Access Compliance Report

Public Rights-of-Way

(Curb Ramps)

Intersection ID: 8173	Main Street: CINDERELLA_RD	Cross Street: HIDDEN_VALLEY_RD	Location:	N
ADA ID: 4A0CA894B7D4	Ramp Type: Perp	Initial Pass/Fail: Fail	Overall Compliance: No	Severity Score: 21.25

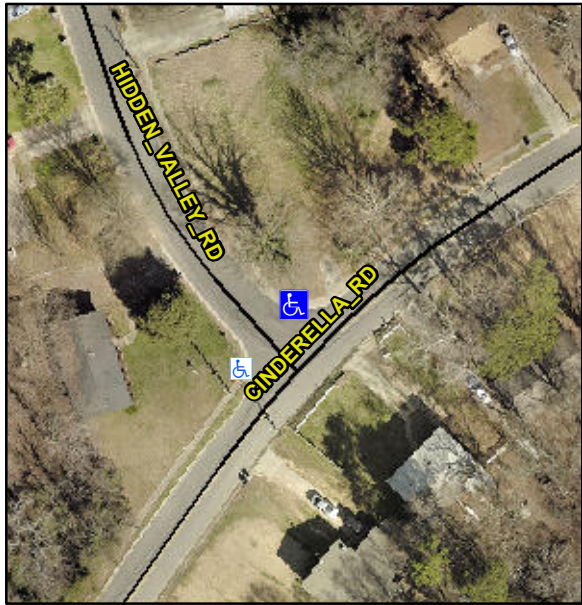
Codes/Mitigation Info/Possible Solution			Field Measurements/Component Compliance					
	Possible Solutions:		Compliance	Description	Data	Compliance	Description	Data
	Remove & Replace Entire Ramp.		N/A	Ramp Length (in)	46.0	Yes	Ramp Slope (%)	5.1
			No	Ramp Width (in)	47.5	No	Ramp XSlope (%)	5.6
			N/A	Flare Type LT	N/A	N/A	Flare Type RT	N/A
			N/A	Flare Slope LT (%)	N/A	N/A	Flare Slope RT (%)	N/A
			N/A	Flare Traversable LT?	N/A	N/A	Flare Traversable RT?	N/A
			N/A	Landing Length (in)	N/A	N/A	DWS Provided?	N/A
			N/A	Landing Width (in)	N/A	N/A	DWS Contrast?	N/A
			N/A	Landing Slope (%)	N/A	N/A	DWS Length (in)	N/A
			N/A	Landing X Slope (%)	N/A	N/A	DWS Full Width?	N/A
Surveyor Notes:			N/A	Landing Curb? (Y/N)	N/A	N/A	DWS Offset (in)	N/A
N/A			N/A	Shared Landing?	N/A			
PROW/ADA:			N/A	Gutter Ponding?	N/A	N/A	Gutter Slope (%)	N/A
Not Found, R304.5.1, R304.5.3			N/A	Gutter Lip Ht (in)	2.5	N/A	Gutter X Slope (%)	N/A
